Lloyd's Register of Shipping.

Ship's Name "Hulda Thorden"Official No. ✓

Memorandum of alterations reported since ship was surveyed for assignment of Load Lines in April 1932.

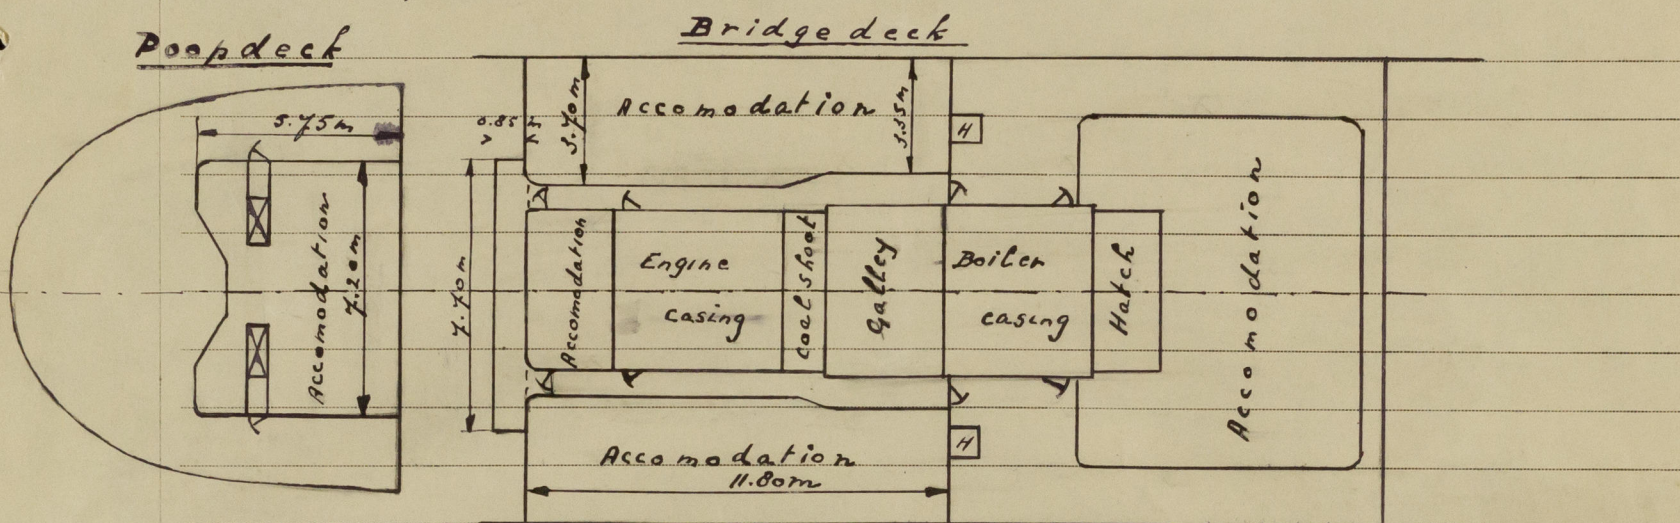
Companion way on fore castle deck removed, opening closed up. ✓
 Forecastle Bulkhead renewed, new opening fitted in the centre, opening 1.60 x 1.20 m, hinged wood doors, operated from both sides, sill 18" ✓

On the bridge deck a wing deck house has been placed (per) as per above sketch, height 2.13 m, existing small wing deck houses against engine casing removed. ✓

The coal bunker hatches have been altered and fitted in front of both new deck houses. Dimensions 1.20 x 0.80 m, height 0.76 m, closing arrangements as required. ✓

A platform has been fitted at after end of bridge, dimensions as per sketch.

On the poop deck a deckhouse has been built, dimensions as per sketch height 2.13 m, enclosing a ladder way (per) Deck opening 1.40 x 0.65 m, door opening 1.60 x 0.65 m, wood hinged doors, operated from both sides, sill 18" ✓

Openings in poop front are closed up, no openings (except port lights) in poop front bulkhead now. ✓
